**Application by St James Homes Ltd.  
Campden Hill Reservoirs Site**

**Campden Hill Reservoir - Proposed S106 Agreement**

Thames Water Reservoir Site

**FORMER CAMPDEN HILL RESERVOIR SITE  
TRANSPORT ISSUES**

TITLE		Campden Hill Reservoir	
TIA PEAK HOUR FLOWS			
DRAWN BY	CHECKED BY	TRACED BY	DATE
RH	<i>sw</i>	RH	May 1999
SCALE	REF		
N.T.S.	FIGURE 1

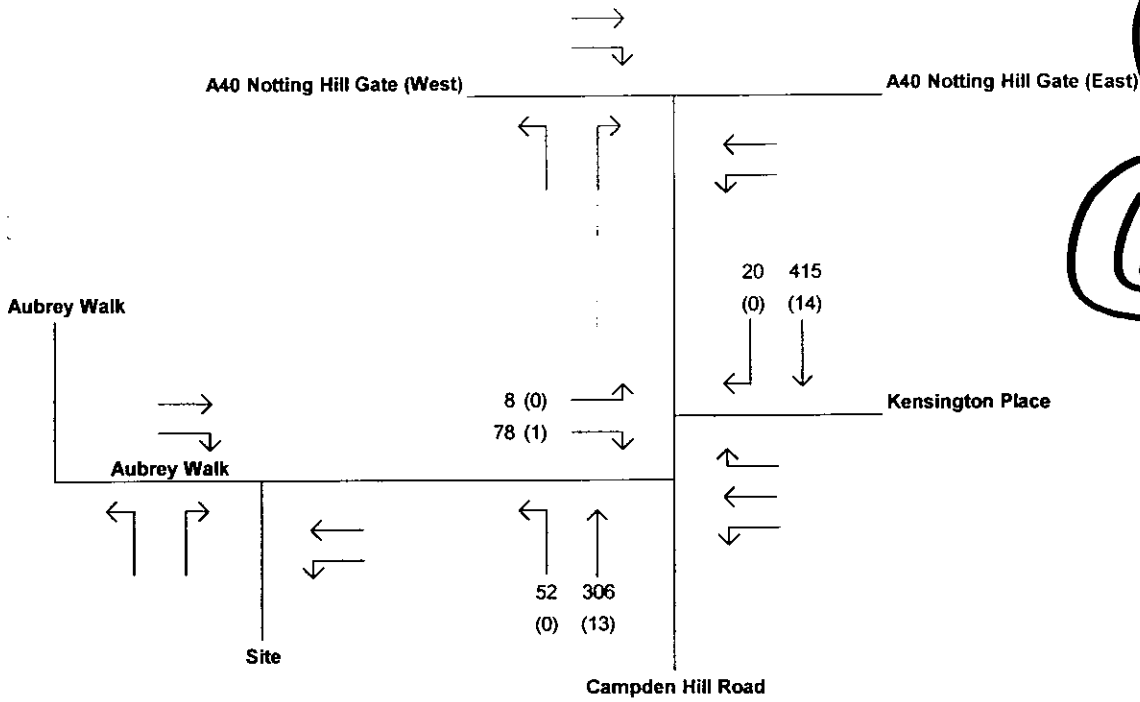
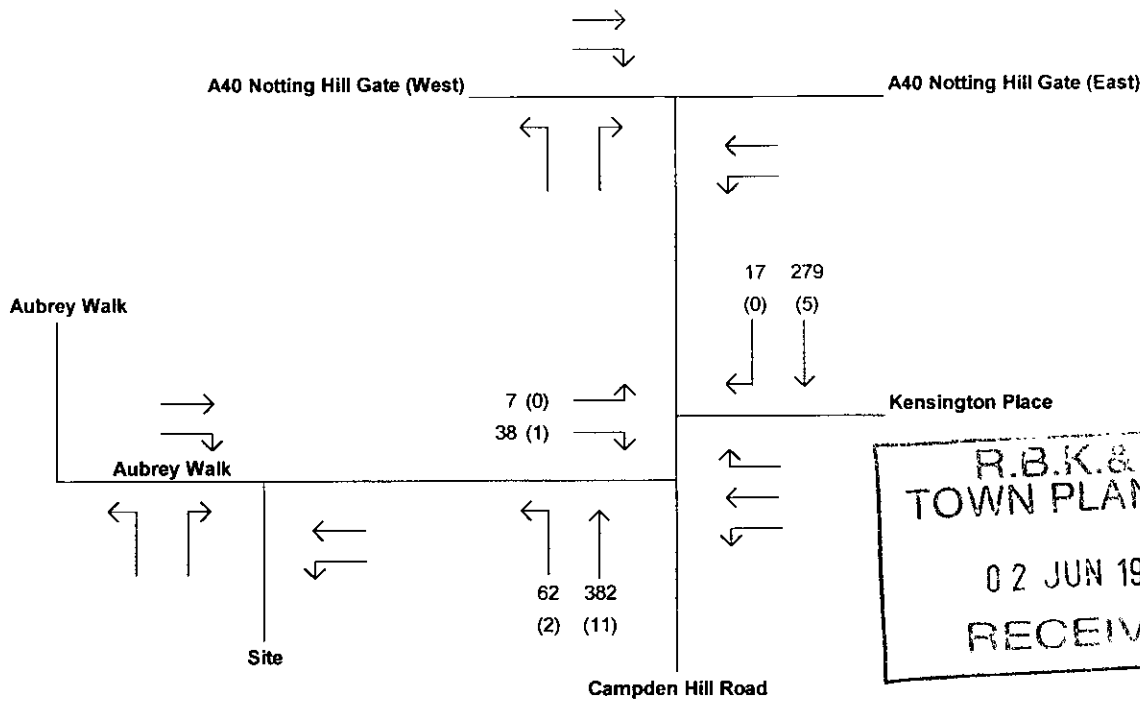
Also enclosed are the results of a traffic count carried out at the Aubrey Walk/Campden Hill Road junction on 29/4/99. Figure 1 (enclosed) summarises the TIA figures, Figure 2 shows the new survey results and Figure 3 quantifies the differences. The results indicate a reduction in flows on Aubrey Walk (-47vph AM and -39vph PM) and an increase on Campden Hill Road (+40vph AM and +122vph PM). The results show the variable nature of day to day traffic flows in this area. However, the magnitude of change is not significant in terms of the capacity of the junctions or the operational assessments contained in the TIA.
